Public comment response

Re: Project File #608020 Cape Cod Bridges Project

Figure 2 - Location of proposed overpass versus existing path plan

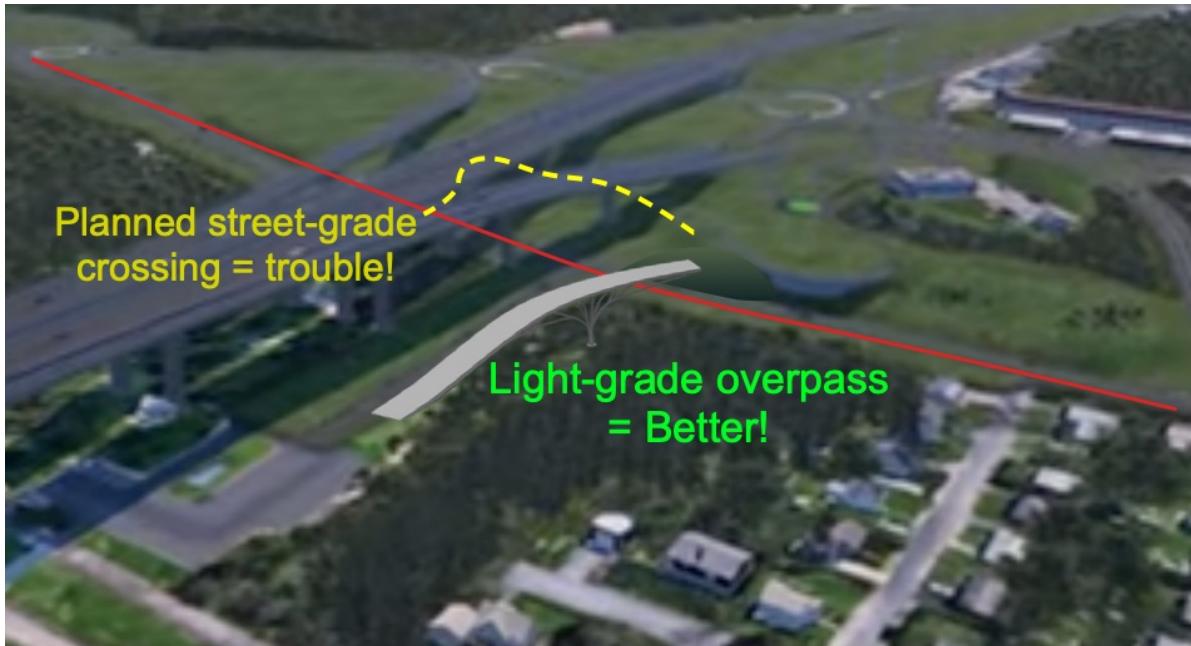
A light, ramped, grade-separated bike & walker overpass is a simple cost-effective solution that **eliminates the issue entirely** by leveraging the existing site elevation, the already-planned retaining wall, and already-available land. Figure 2 illustrates this.

- **Better supports event surges.** Large-scale events can proceed without closing the Canal Service Road or requiring law enforcement control. Smaller events won't cause otherwise-likely traffic backups.
- **Further encourages usage.** Encourages increased year-round use by locals and visitors by eliminating fear of car collisions.
- **Improves site impact.** Utilizing existing right-of-way maintains land alignment, leverages the descending elevation, and eliminates extra berms and erosion control.

- **Simplifies canal bike path connection.** The overpass can safely exit near most users' destination - the bike path.
- **Eliminates vehicle-human conflict.** Period. The overpass entirely avoids the interaction between bikes & walkers, and eliminates driver interference.

Figure 3 - Descent Ramp into existing public property

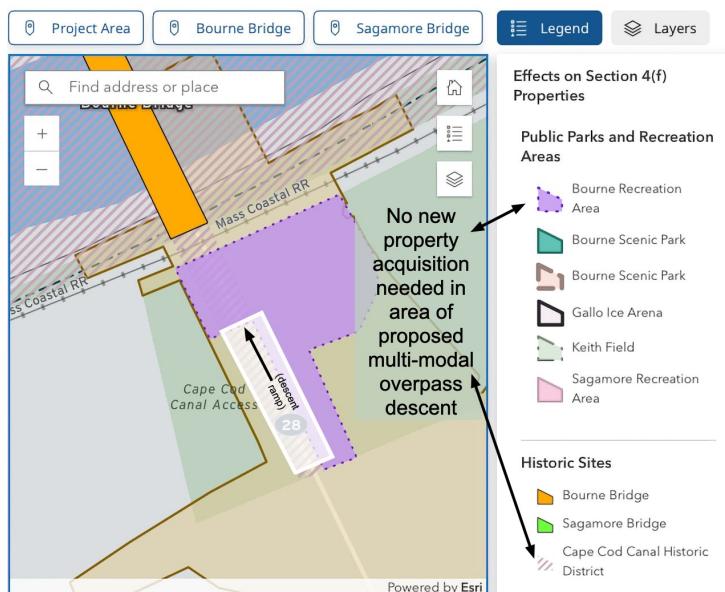
- **The change leverages planned structures.** A structural berm and major path descent are already included in the current plan; these elements can be reworked to form the southerly approach to the overpass. The northerly descent can be accommodated by a light, non-vehicular structure. A preliminary examination by project engineers indicates that replacing the planned path with an overpass is feasible.²
- **No new property required.** The northern side of the overpass, which constitutes the descent over grade, can descend into the existing Bourne Recreation Area and Cape Cod Canal District property. No property taking is required. See rough placement illustrated in Figures 3 & 4.
